THE MARYLAND-NATIONAL CAPITAL PARK AND PLANNING COMMISSION

MEMORANDUM

REVIEW TYPE: Preliminary Plan Application

PROJECT NAME: Armenian Youth Center
CASE NO. 1-00009

PRELIMINARY PLAN
ARMENIAN YOUTH CENTER
OF
GREATER WASHINGTON, INC.
MONTGOMERY COUNTY, MARYLAND

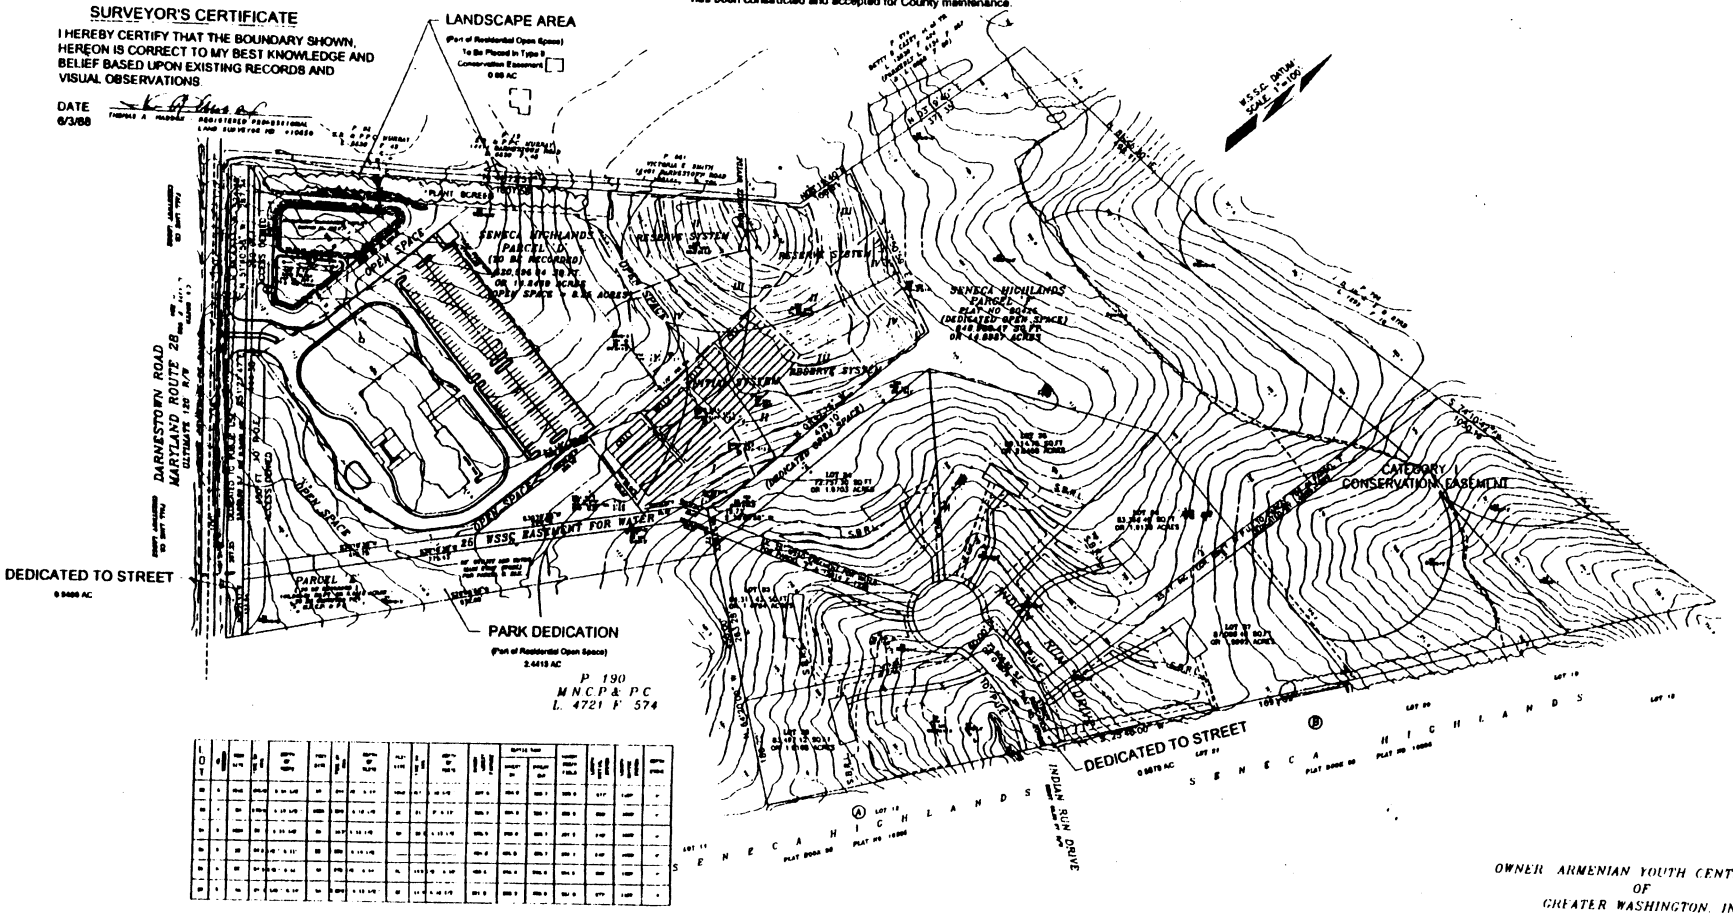
The preliminary plan application for the house of worship has remained constant with the prior approval. Some slight modifications to the septic reserve areas have been depicted to reflect current reviews and the area of park dedication has been redefined to better accommodate the future expansion of the parking facility

(1) At least one-hundred and twenty (120) days prior to the recordation of plat, applicant to submit to the AYC Homeowners Association an agreement to rescind the Leasing and Management Agreement dated January 15, 1998 with a copy to the Commission's Legal Staff. The applicant must submit a signed agreement or affidavit that the AYC HOA failed to return executed agreement within ninety (90) days of receipt of precision agreement

(2) Prior to recording of plat, applicant to submit a final landscape plan for technical staff review. Landscape plan to provide additional buffer areas along the northwest and southeast property lines adjoining the existing residential development

(3) Final record plat to include the area of park dedication and property for the house of worship. Both areas to be recorded simultaneously

(4) Conditions of Department of Permitting Services approval of the stormwater management concept date June 7, 2002

(5) Final access and improvements, as required to be approved by MDSHA prior to issuance of building permit

(6) All road right of way shown on the approved preliminary plan shall be dedicated by the applicant, to the full width mandated by the Potomac Subregion Master Plan, unless otherwise designated on the preliminary plan

(7) Dedication of Darnestown Road (MD 28) as shown on preliminary plan

(8) Record plat to provide a landscape buffer/open space easement area of .66 acres (28,750 square Feet) along the northwest property line

Attachment 1

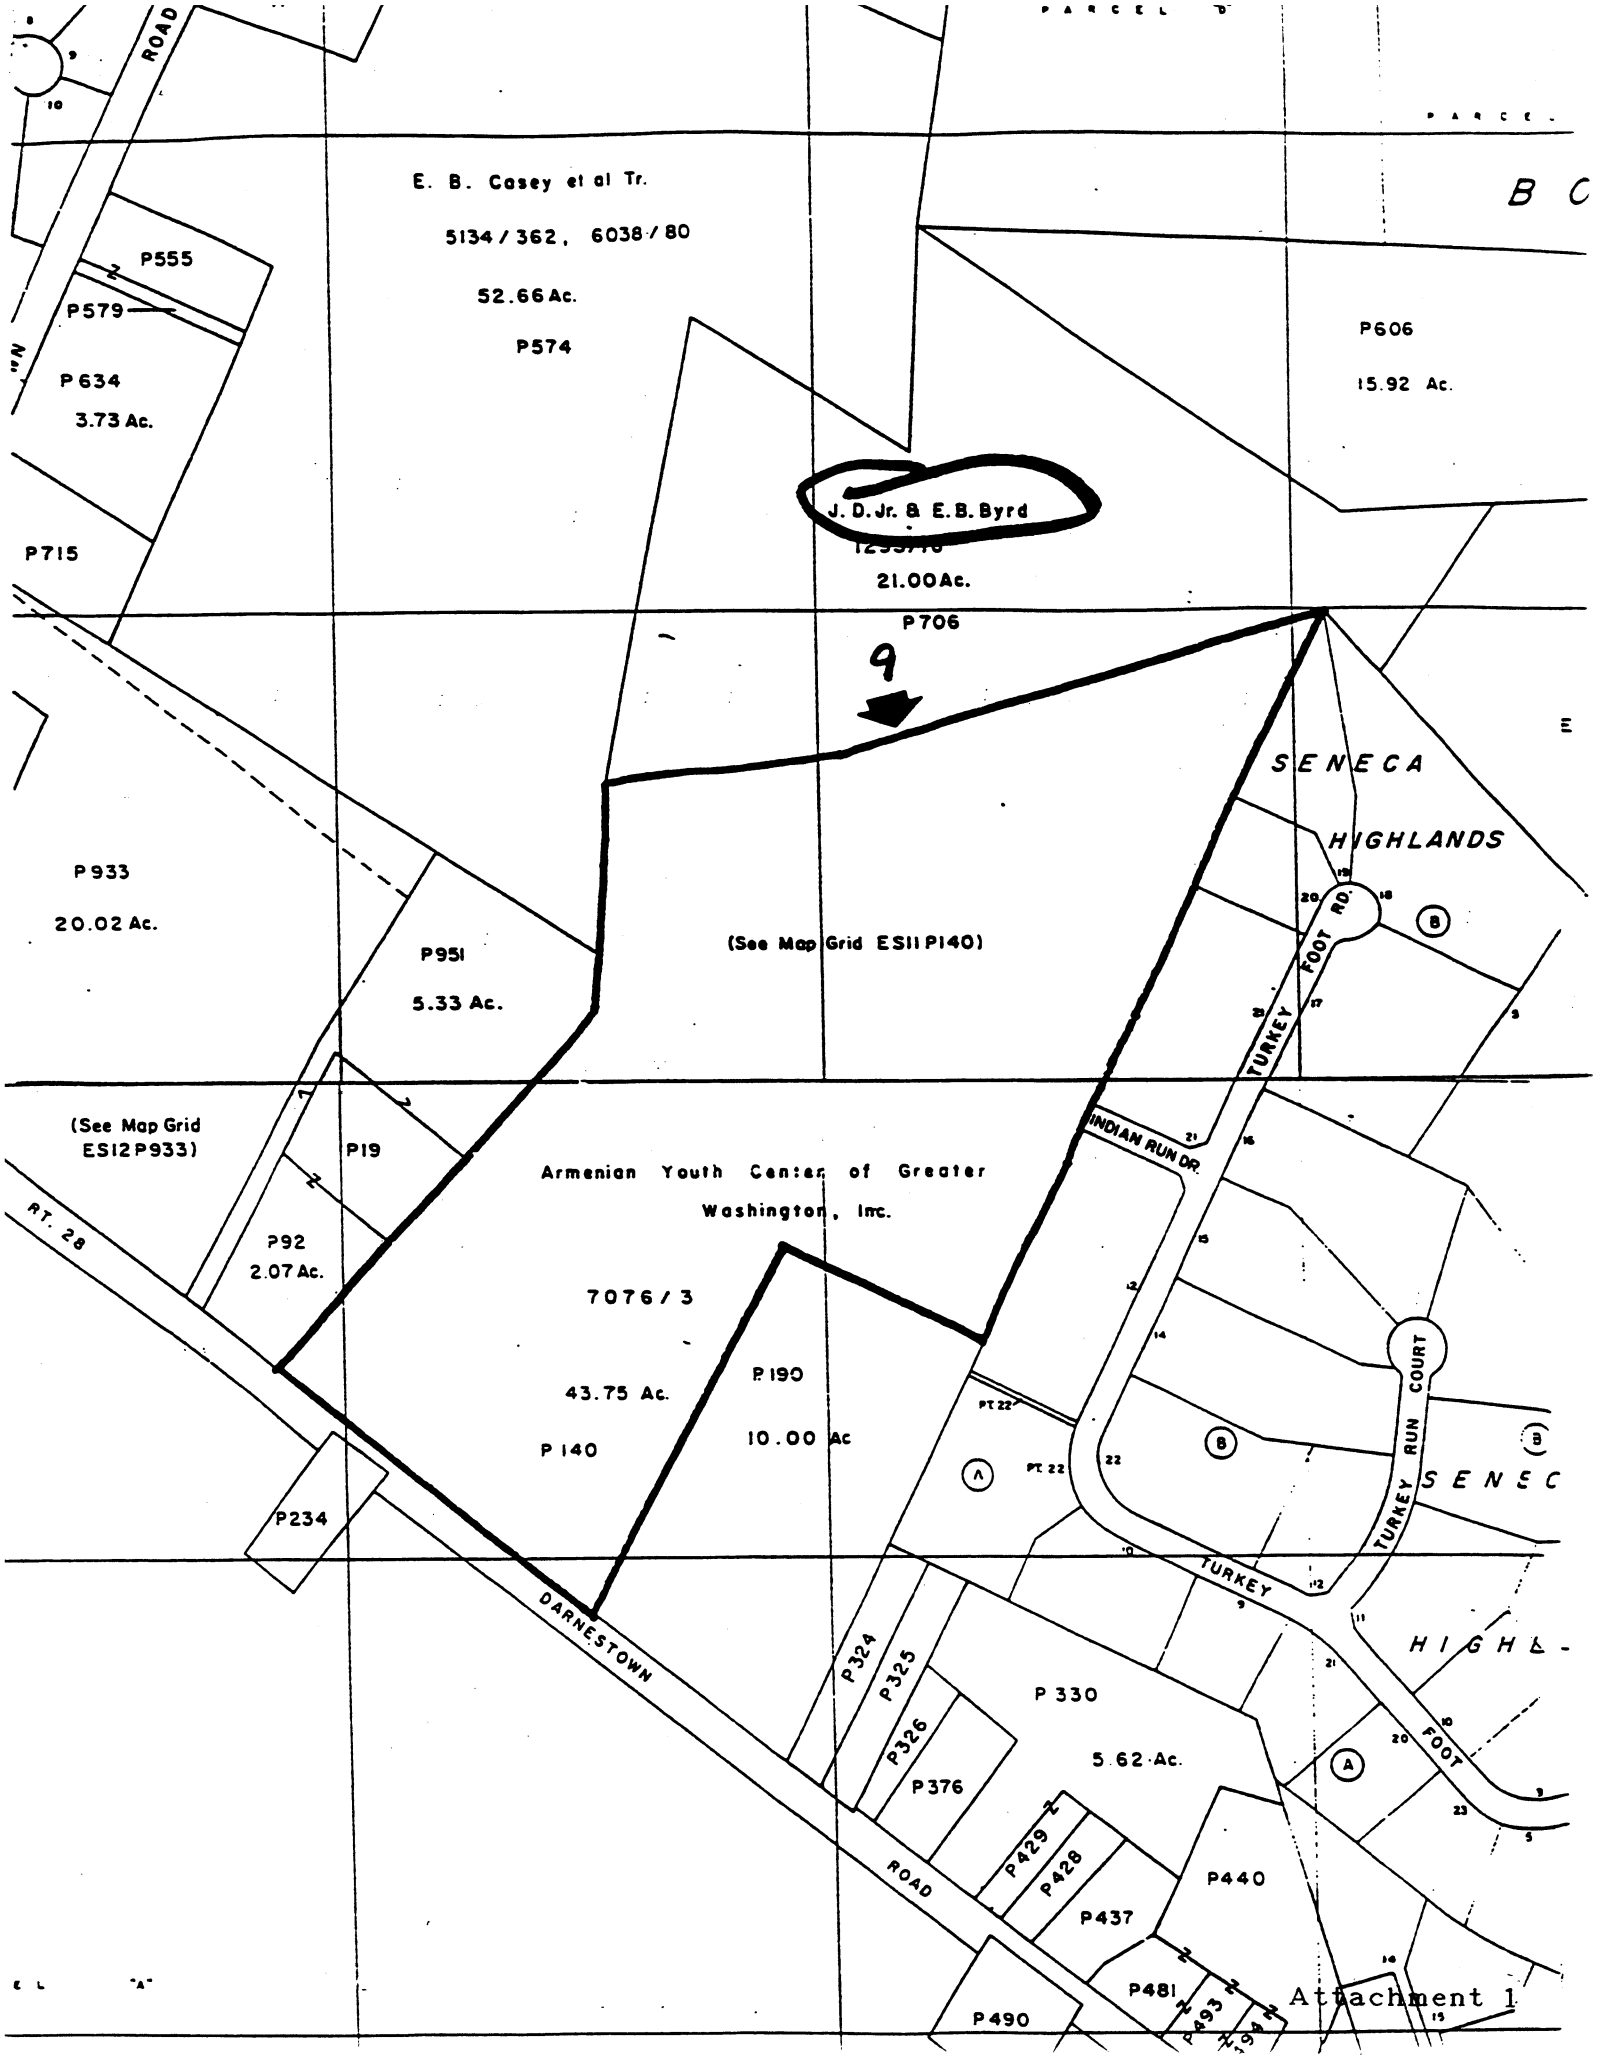
(3) Revise the residential open space delineated on preliminary plan to delete the 30' panhandle proposed along the northwest property line of the House of Worship lot (Lot 107). This area should be incorporated into Lot 107.

(5) Delineate area encompassing the 60% open space required for Lot 107.

(6) Provide minimum 30' wide landscaped buffer strip along the northwest property line to provide a wooded buffer between House of Worship and adjacent residential developments.
